Product: Dishwasher	Diverter valve PMS_2019_01	Reference: Service Support
Update: 2019-10-10		Version: 00

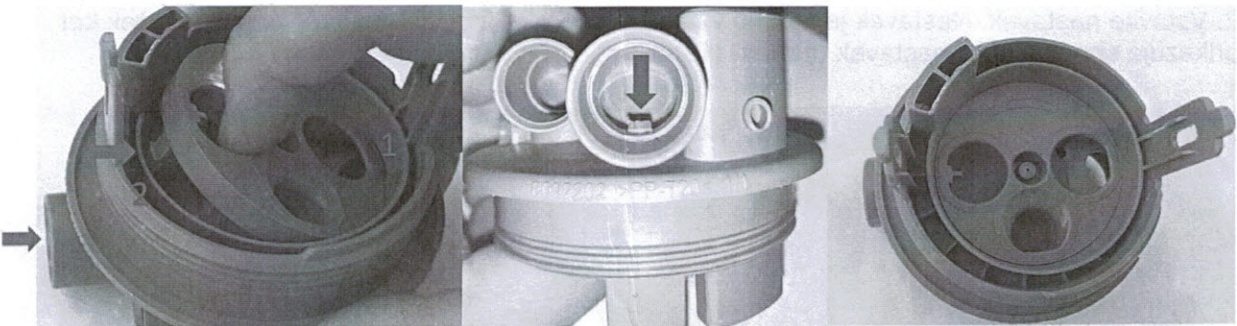
From date 17.09.2109 or. Serial number 9383... there is a new diverter valve. New diverter valve isn't backward compatible (until serial 9383...) because of that it is necessary to install also the insert.

1. Disconnect wiring harness and remove the diverter valve from two hooks (one front one back).

2. Install the insert. Insert is possible to install only in one position. Install it in sequence like on photo bellow (a click must be heard).

3. Attach the new diverter valve and do a **TOTAL RESET 02**.
